FIVE ESTUARIES OFFSHORE WIND FARM

10.48 RED THROATED DIVER NOTE

Applicaton Reference	EN010115
Application Document Number	10.48
Revision	A
Pursuant to	Deadline 6
EcoDoc Number	005644366-01
Date	February 2025

Figure 2.1. Red-throated diver densities (Irwin *et al*, 2019) and the shipping densities along the ECC

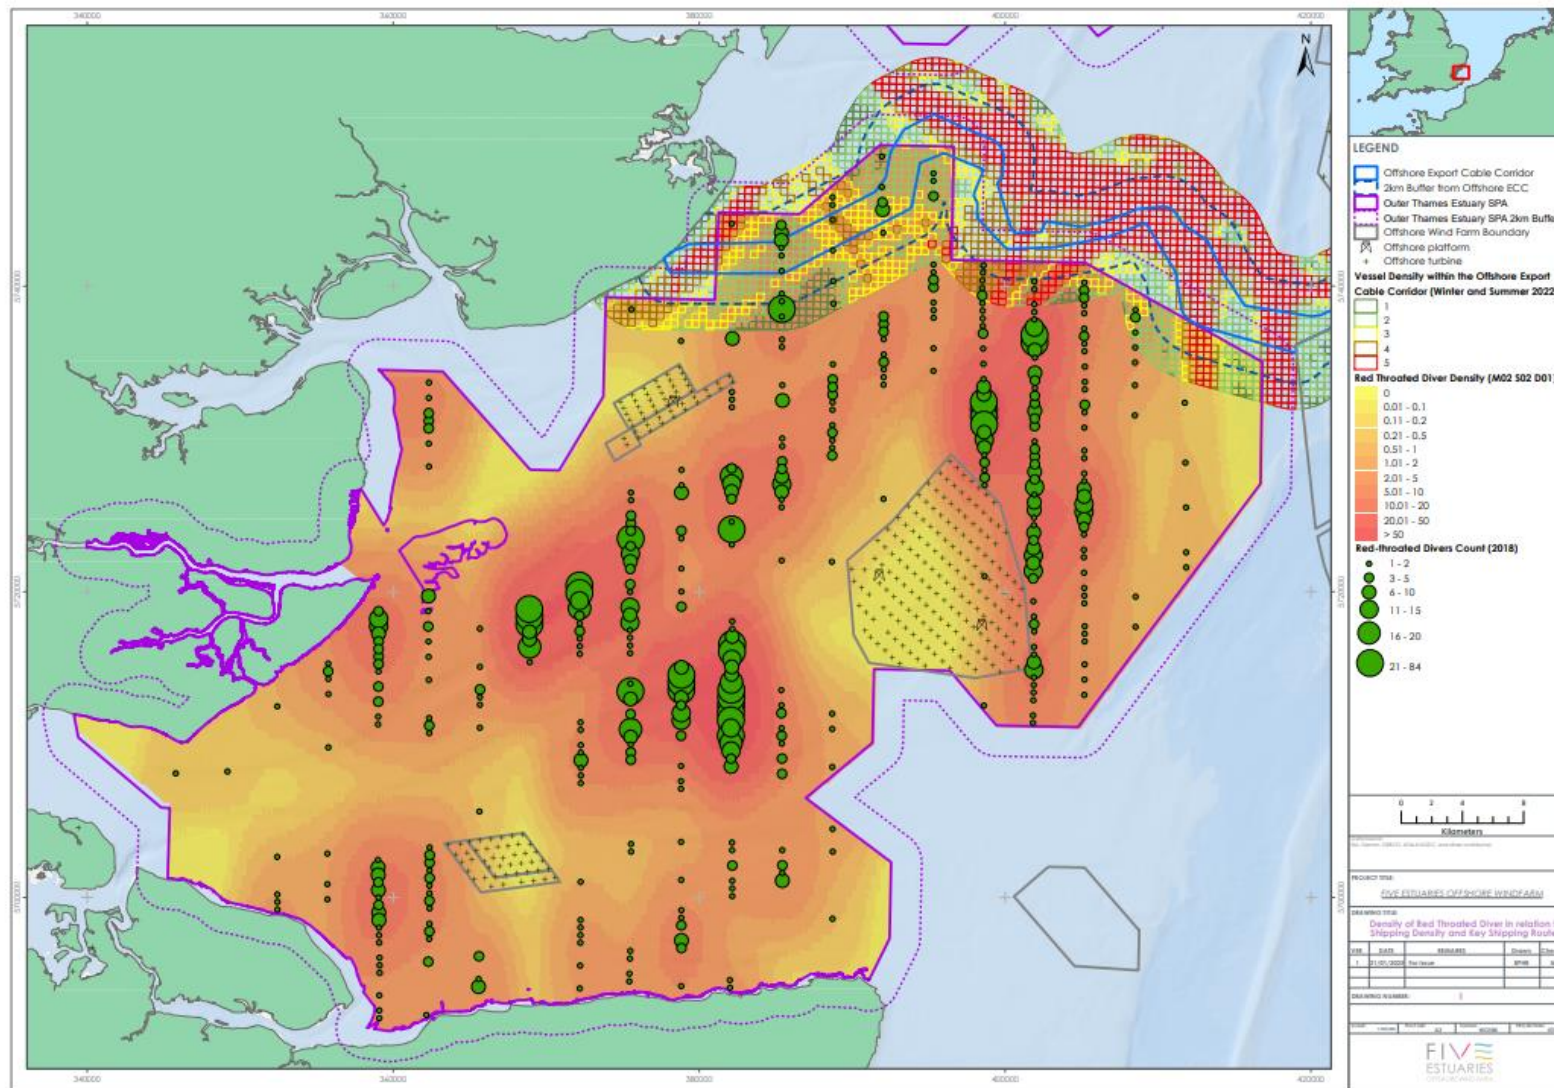
- 2.1.20 The red-throated diver densities and distributions are presented in Figure 2.1 using the data from Irwin *et al* (2019). The data from Irwin shows that the RTD densities within the ECC are not high and shipping data overlain onto the ECC (Figure 2.1) from within the ECC show medium to high vessel traffic.

- 2.1.21 Therefore, the ECC does not cover areas of unimpacted habitat and densities of red-throated diver are low in the shipping lanes in the area. It should be noted that there are high density areas immediately outside of the shipping lanes suggesting that a 2 km buffer is overly precautionary in this area.

Figure 2.2. Map presenting the shipping densities and the red-throated diver counts from Irwin *et al.* (2019).

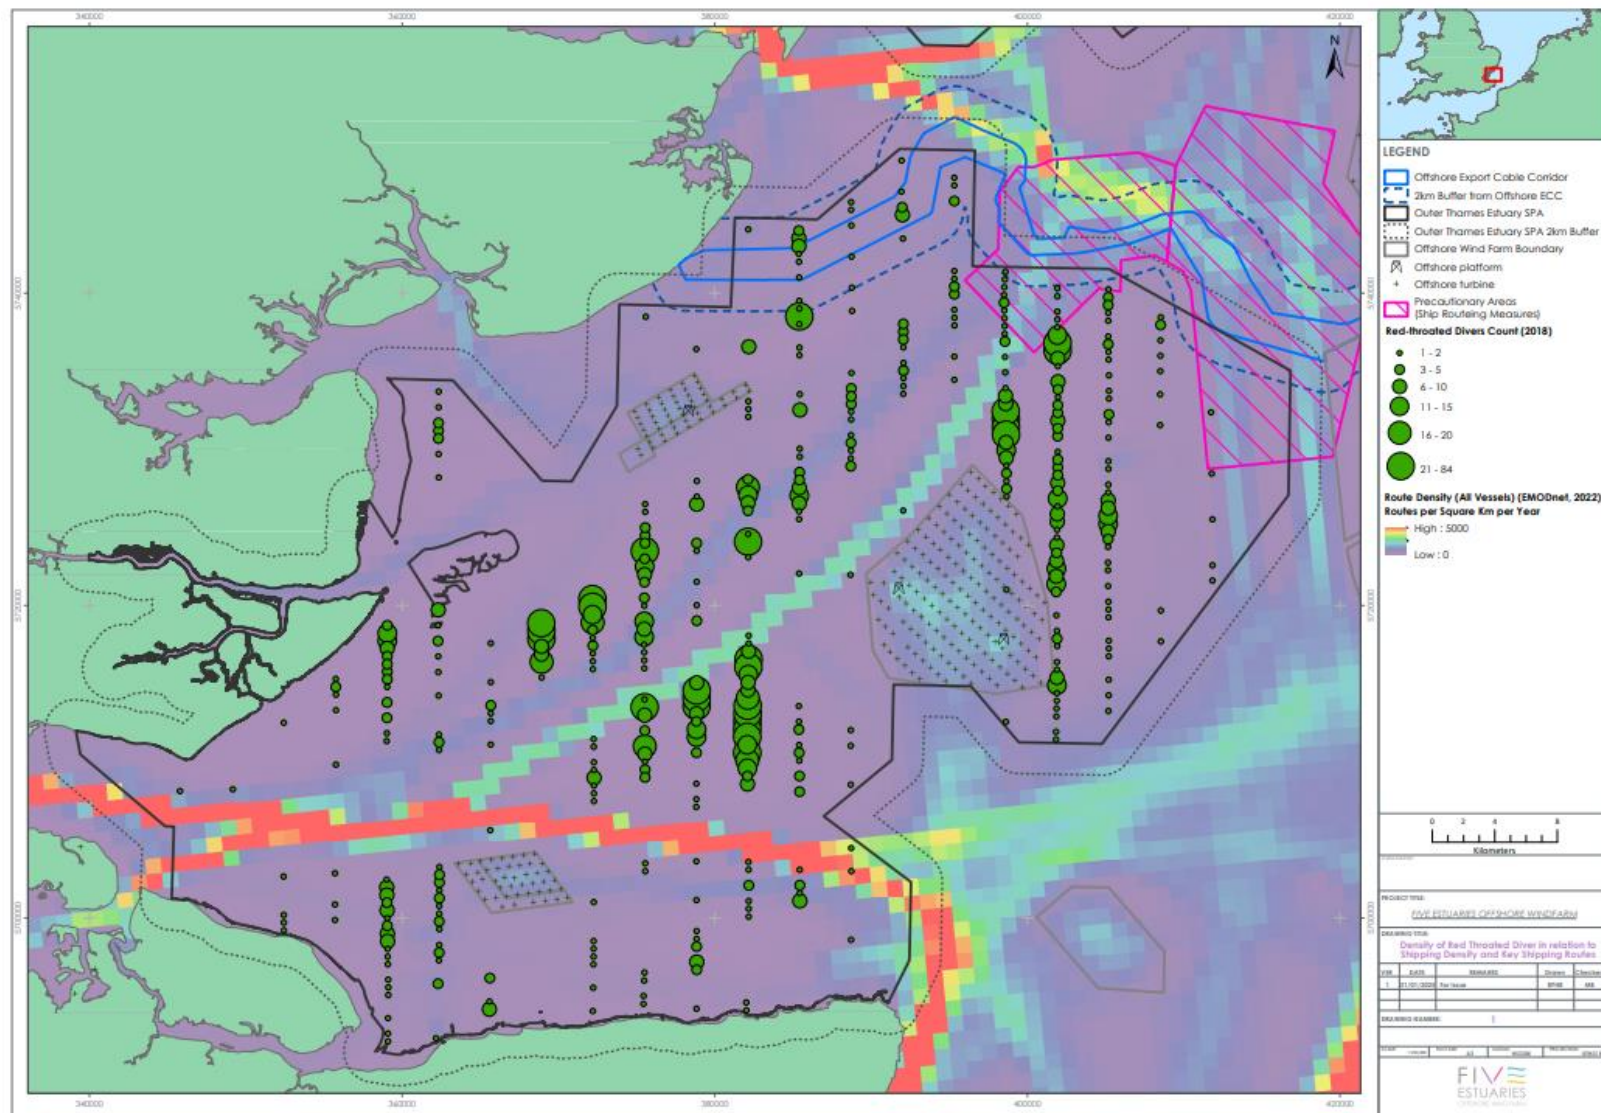
- 2.1.22 Figure 2.2 highlights this further, with vessel tracks distinctly showing key shipping routes in this area, primarily the deep water routes (DWR), the Sunk DWR in particular, running south right through the OTE SPA eventually joining the Black Deep water Route which runs into the Thames River. It should be noted that the Precautionary Areas (shown by the pink hatched area in Figure 2.2) overlaps with the VE ECC. These are in place due to the high density of vessel traffic and is deemed a “high risk traffic area” where vessels often wait and/ or anchor until pilotage is available into the various large ports situated along the coast.

- 2.1.23 As highlighted above RTD densities are low in these areas, and therefore the addition of a small number of project vessels during cable laying activities over a small time period would not be additive to the levels of disturbance already within this area.
